Subject: ER # 2017-2210-042 Site Modifications

Adelphia Gateway, LLC (Adelphia) is proposing some modifications to nine Adelphia Gateway Project (Project) sites. Although the modifications are relatively minor and would not include any new excavations outside of existing trenches, the PA DEP is requesting PHMC review of the modifications as part of their Completeness Review for the associated Phase 1 Major Amendment to the Project's Erosion and Sediment Control Permit application.

# PROJECT REVIEW FORM

# Mainline Valve 2

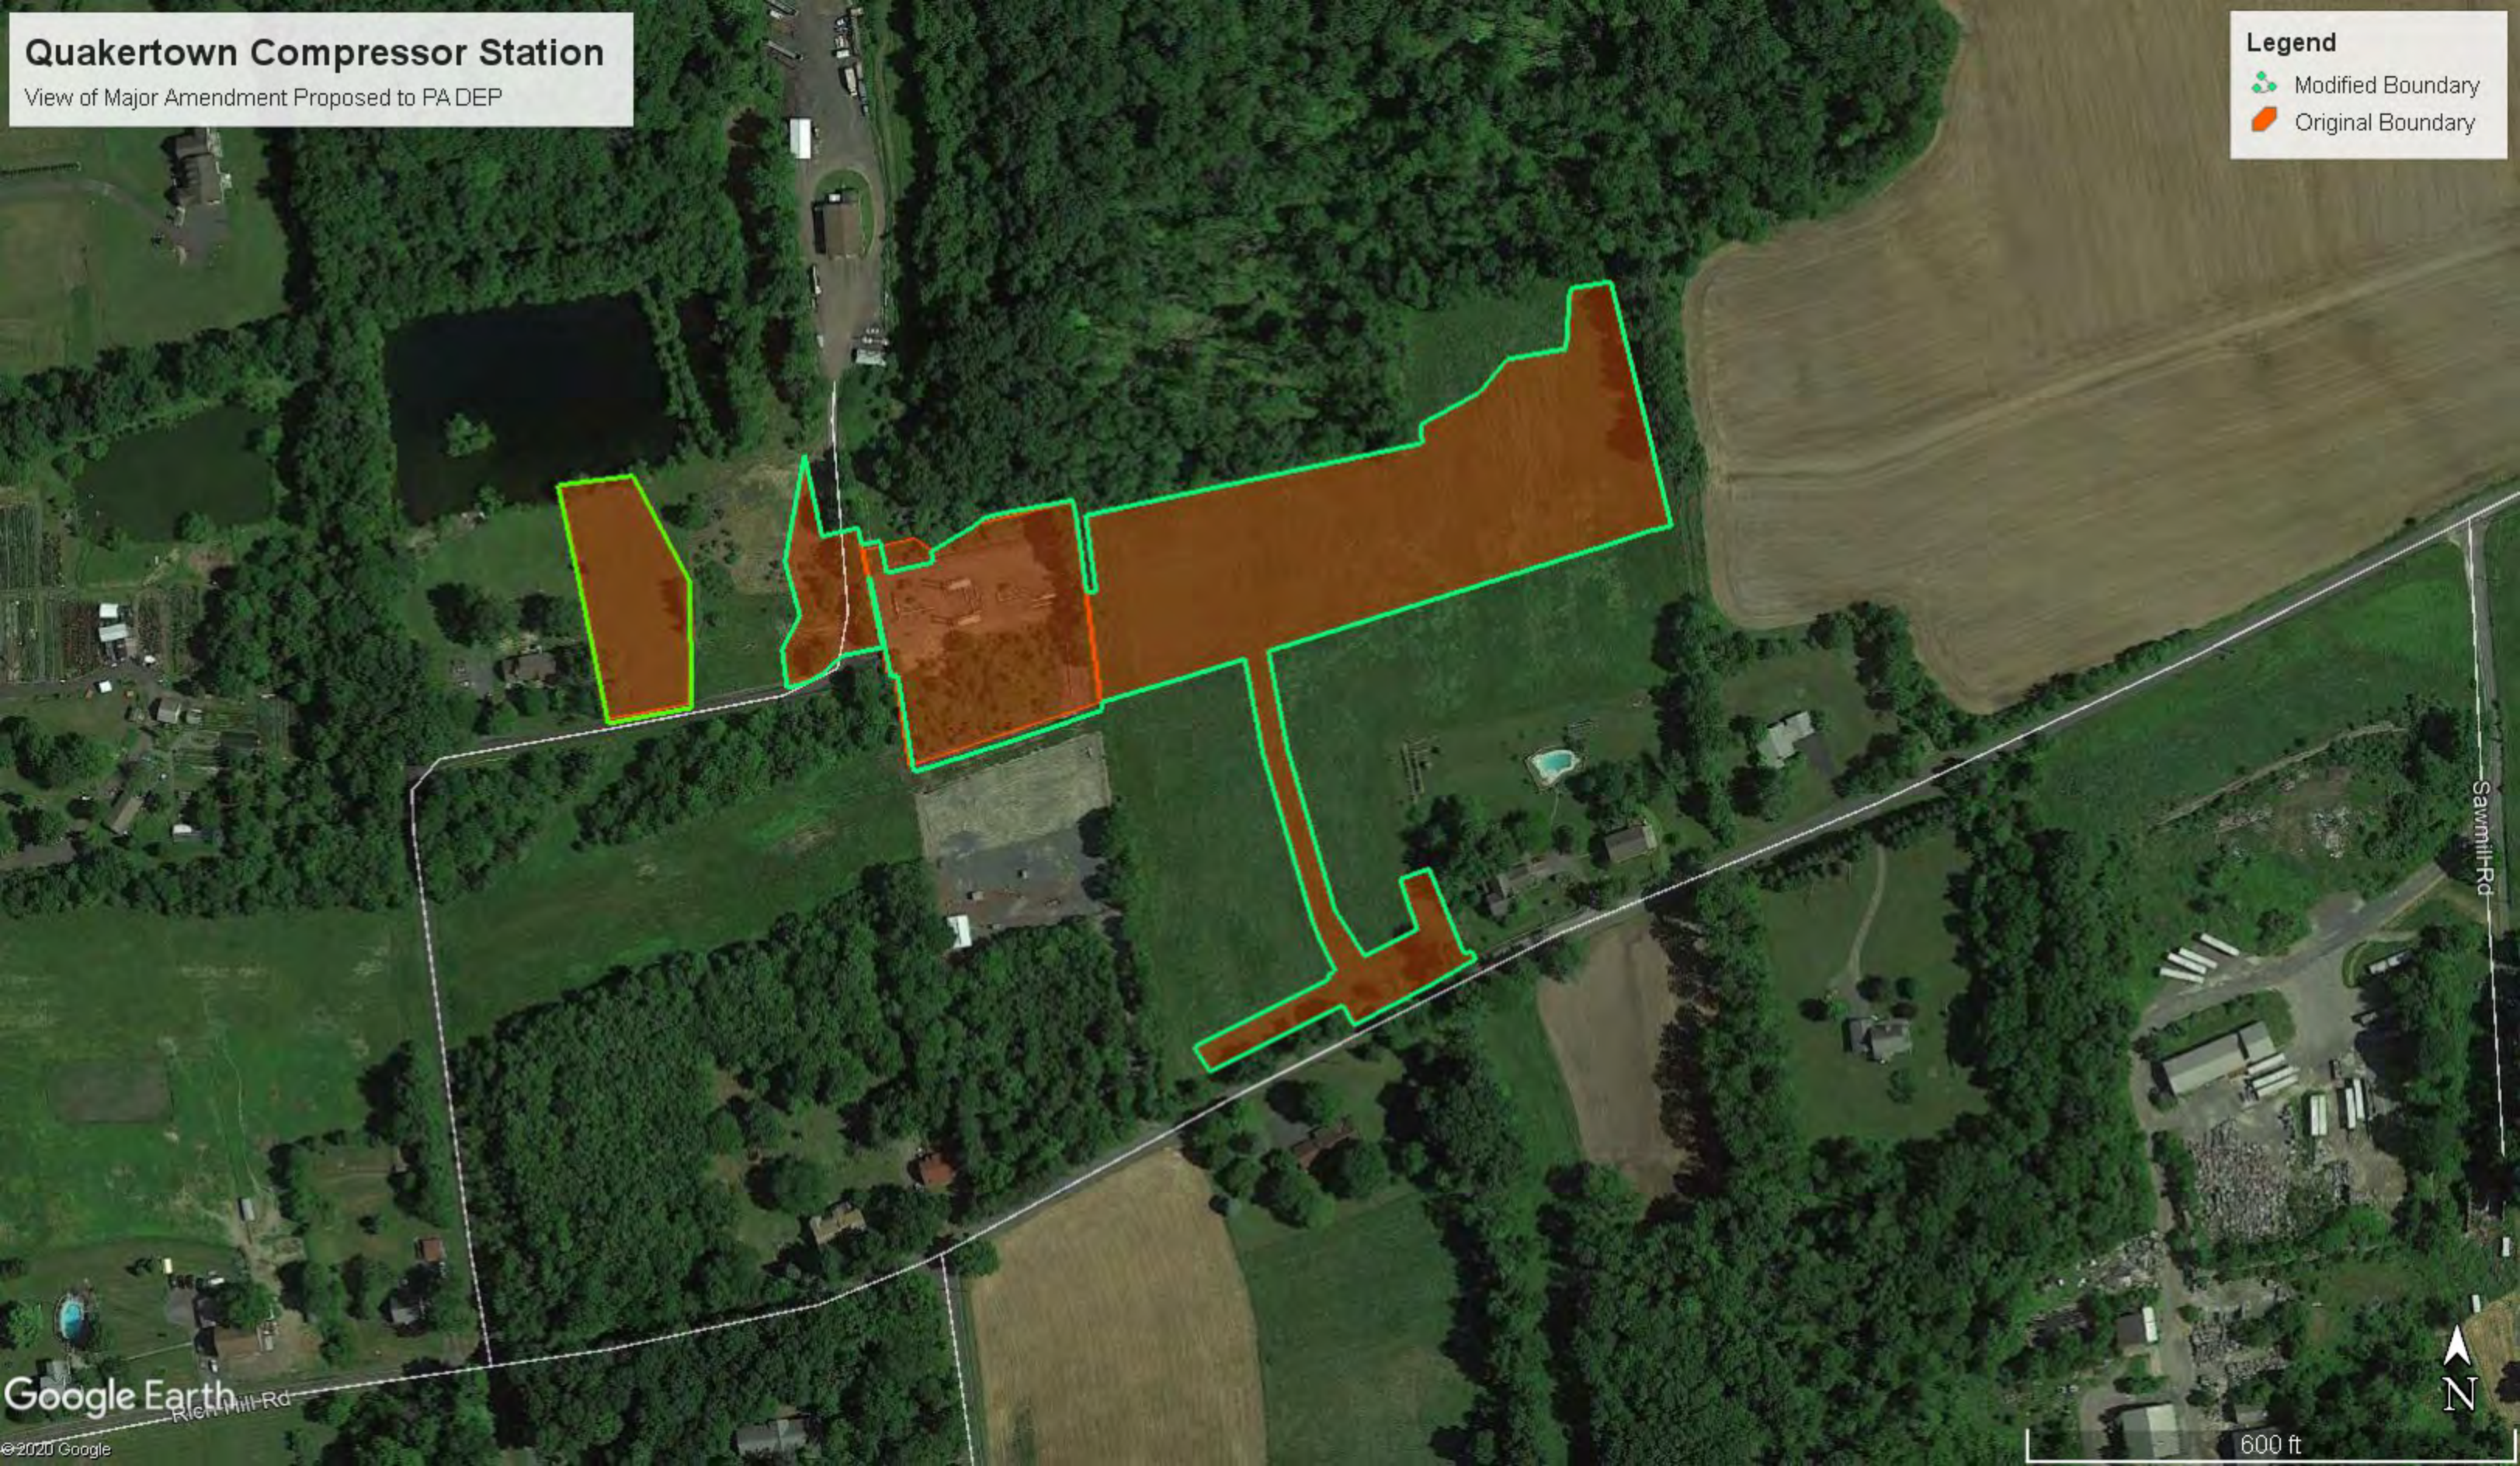
4. **Marcus Hook Compressor Station** – Adelphia proposes to reduce the limits of disturbance for this site.
5. **Mainline Valve #2** – Adelphia proposes to add TWS north and south of the existing TWS within the existing maintained pipeline ROW to provide adequate workspace.
